DCP/NRC1486
Project 711

SUBJECT: Transmittal of Westinghouse Responses to Requests for Additional
Information (RAIs) for AP1000 Pre-Certification Review

AP1000 PRE-CERTIFICATION REVIEW

REQUEST FOR ADDITIONAL INFORMATION

Figure 1: PRHR Component Test Results (Ref. 1)

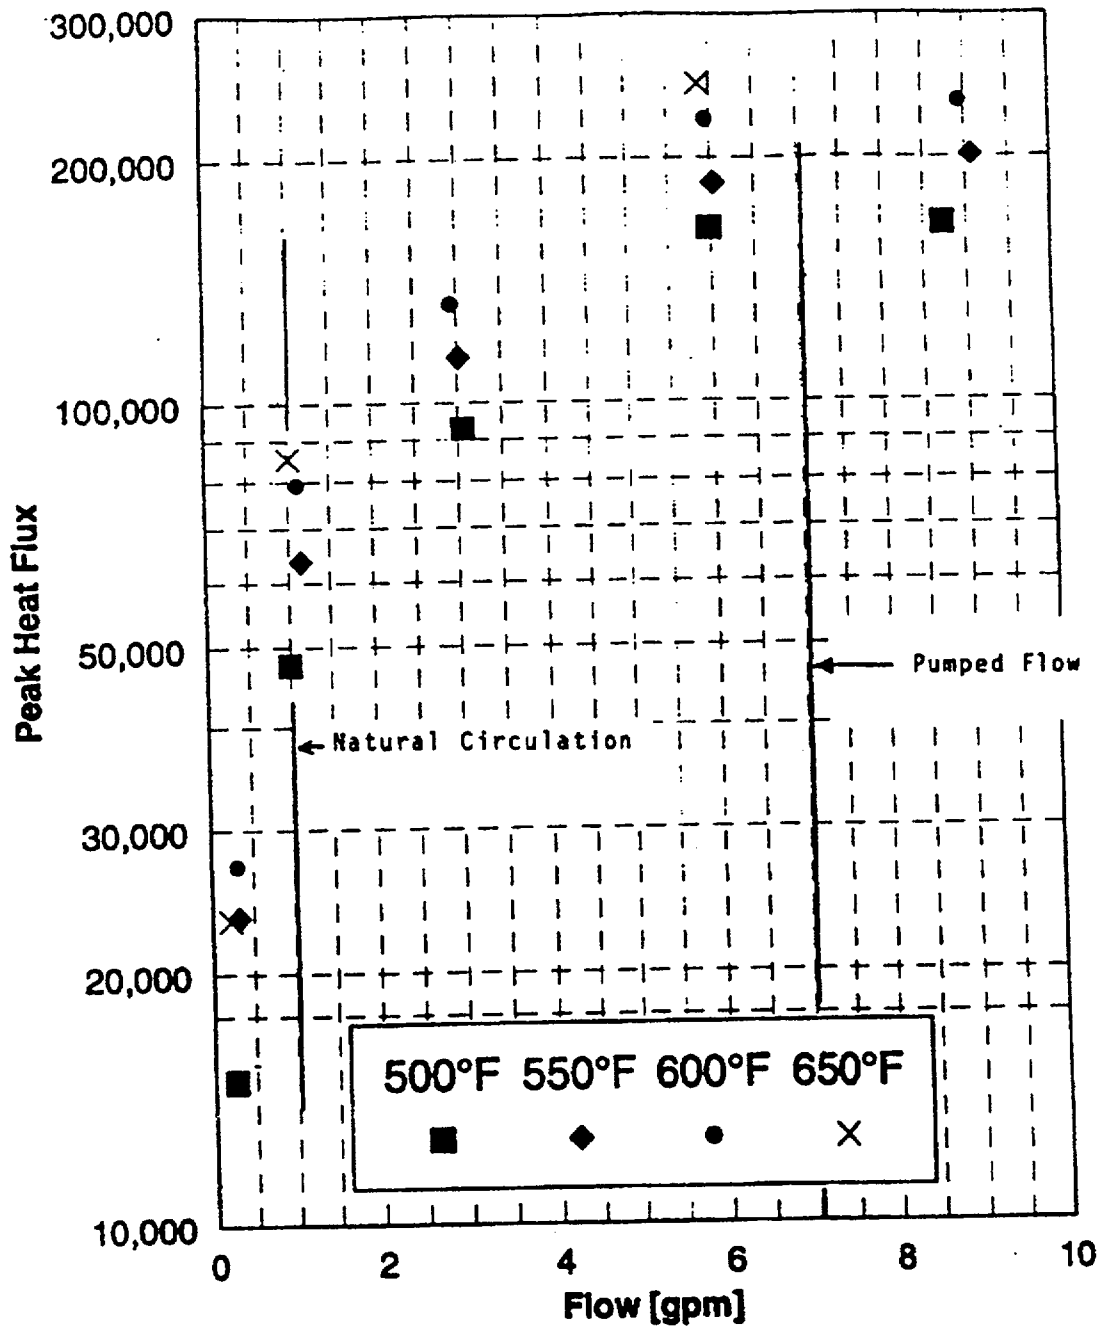
The PRHR for AP1000 will be 22% larger than for AP600, but the average heat flux is expected to be 42% greater. Justify that the expected heat flux is bounded by test conditions. Justify that the heat transfer correlations in NOTRUMP and LOFTRAN codes are adequate to model the greater heat flux.

Figure 1 from Reference 1 shows the range of heat flux conditions that were covered by the AP600 PRHR heat exchanger test. The tests covered heat fluxes as high as 250,000 BTU/hr-ft². In LOFTRAN, the PRHR heat transfer correlation is applied, unless the calculated heat flux is greater than Critical Heat Flux (CHF). The correlation is therefore applied up to CHF. Figure 2 from Reference 2 shows the calculated heat flux for the AP600 and AP1000 PRHR heat exchangers under both natural circulation, and forced flow conditions. For all cases, the calculated heat flux, as predicted using the PRHR correlation, is much lower than

the CHF limit. Therefore, the boiling heat transfer correlation developed from the AP600 PRHR tests can be used to predict boiling heat transfer for the AP1000 PRHR heat exchanger.

Figure P33-1

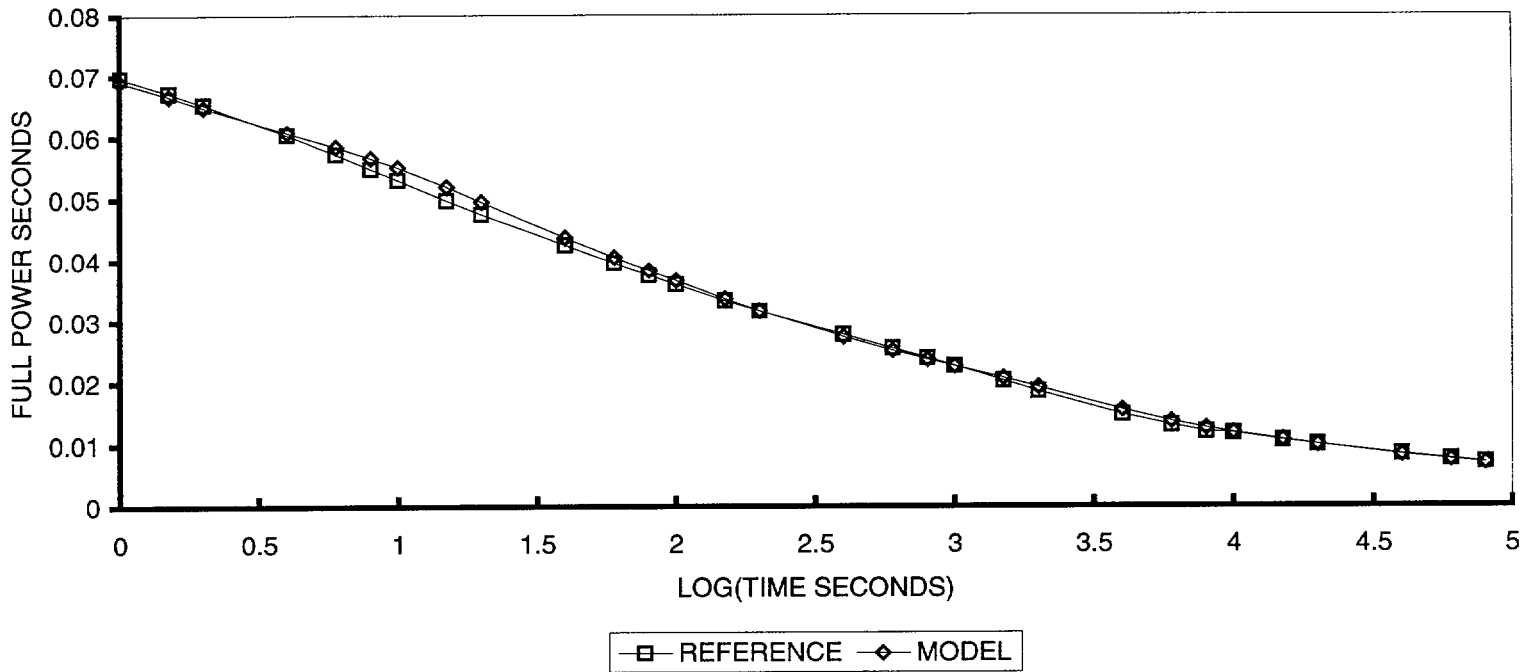
Describe the decay heat model that will be used in LOFTRAN for AP1000 analysis. Justify that this model is conservative for transient and accident analysis. Provide comparisons of the model with the American Nuclear Society Standard 5.1.

The generic decay heat curves developed above bound Westinghouse standard and optimized fuel design with 15x15, 16x16, 17x17 fuel assembly configurations. The attached figures show a comparison plot of LOFTRAN calculated decay heat curve using nine exponential terms against the bounding generic ANSI/ANS-5.1-1979 decay heat model. The exponential terms may be input depending upon conservatism desired in the analyses or time duration of the event analyzed.

Figure P50-1: ADS-4 Steam Flow – 2inch Cold Leg Break

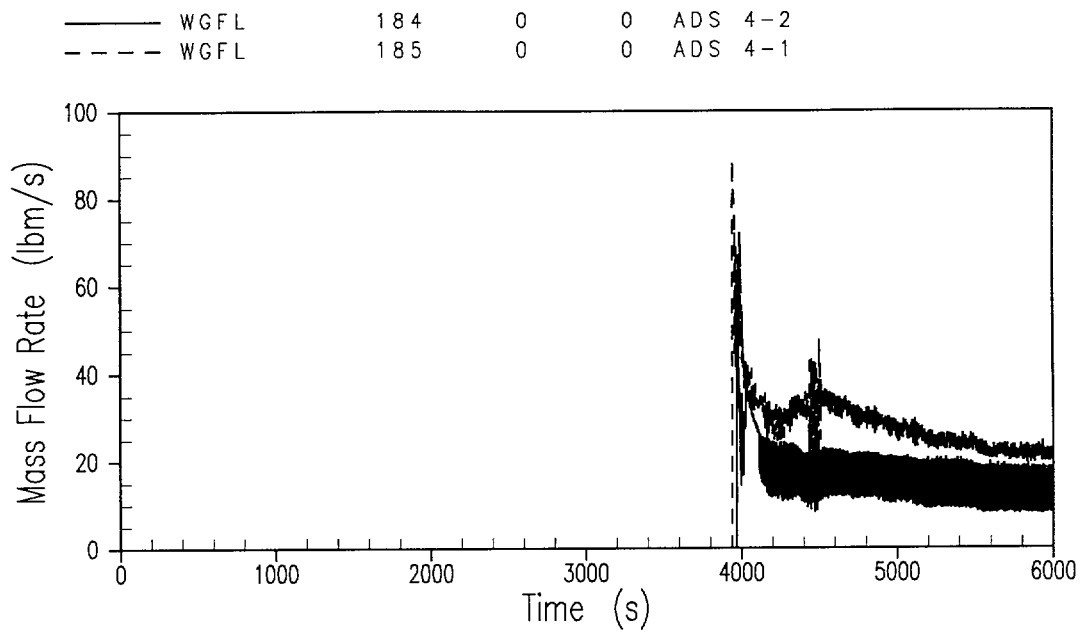
Provide the Automatic Depressurization System Stage 4 (ADS-4) vapor phase flow rate for the 2-inch cold leg break to accompany Figure 3.3.1.4-31 of WCAP-15612, and a figure or table providing the water level in the hot legs for this transient. Also provide the core exit vapor flow rate.

Please see the attached figures and table. The results provided correspond to the analysis of 2-inch cold leg break presented in WCAP-15612, "AP1000 Plant Description and Analysis Report."

Note that ADS4-2 is atop Hot Leg 1, and ADS4-1 is atop Hot Leg 2 in the legends of the plots.

Figure P51-1: ADS-4 Steam Flow – Double-ended DVI Break

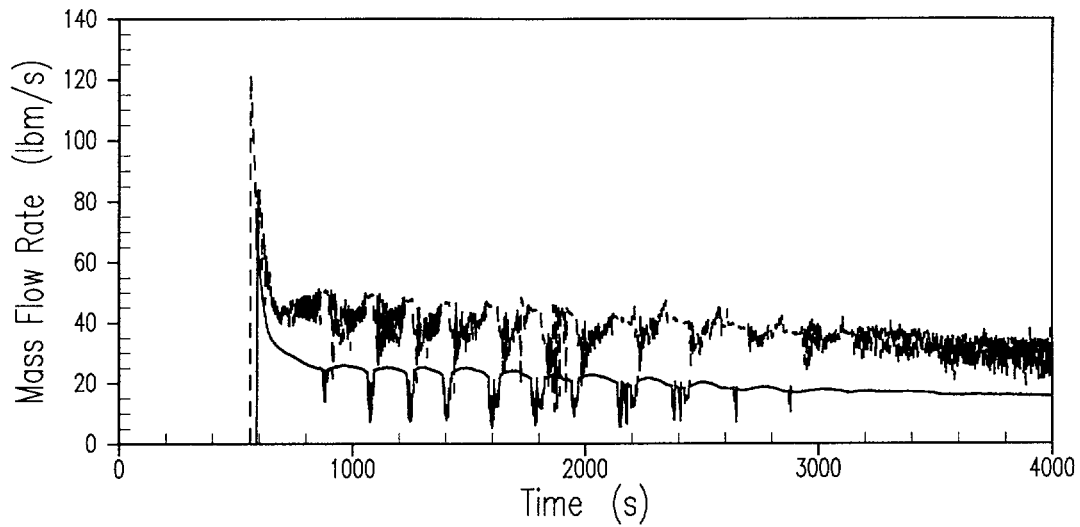
Provide the expected ADS-4 vapor phase flow rate for the DEDVI (double-ended direct vessel injection line) break, and the water level in the hot legs for this transient.

Please see the attached figures and table. The results provided correspond to the analysis of DEDVI presented in WCAP-15612, "AP1000 Plant Description and Analysis Report."

Note that ADS4-2 is atop Hot Leg 1, and ADS4-1 is atop Hot Leg 2 in the legends of the plots.

Figure P53-1: ADS-4 Liquid Flow – DEDVI Break

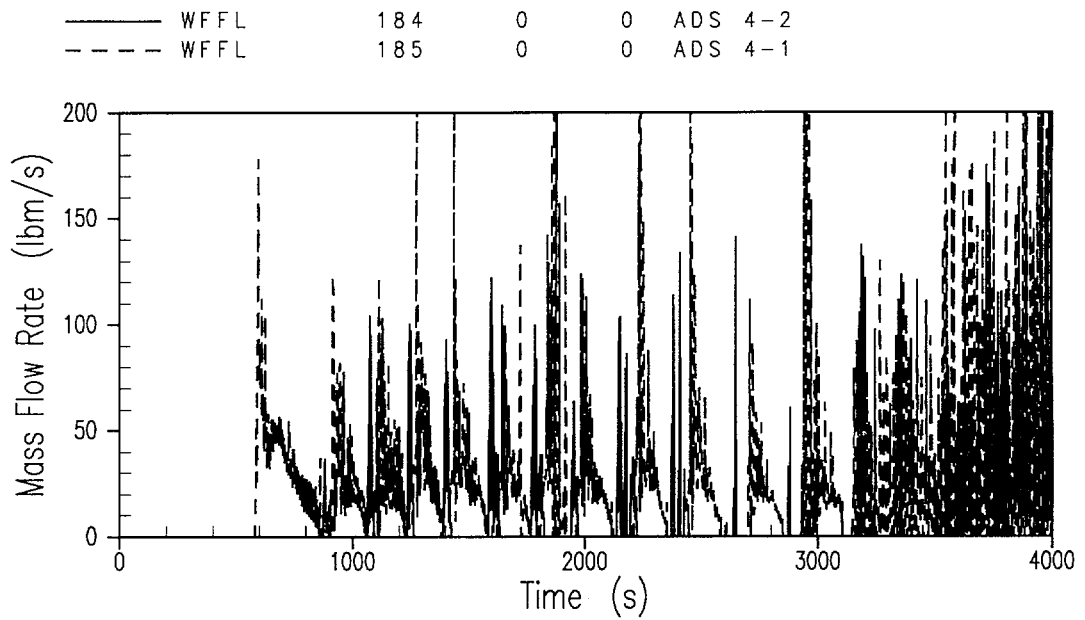
(ii) The second distortion, “effect of reactor pressure vessel injection from the pressurizer,” was present in all three integral effects test facilities and is due to distortion in the pressurizer surge line flow. The distortion in APEX was considered non-conservative, because of disproportionately low ADS-4 flow. The scaling parameter for “Effect of pressurizer injection” is:

Which represents the ratio of the vessel liquid inflow and outflow from the CMT and pressurizer and the flow out the ADS-4. Provide flows to determine $(W_l)_0$ and $(W_{ADS4})_0$ for the DEDVI line break

- (ii) The requested flow rates are quantities are shown in the attached figures.
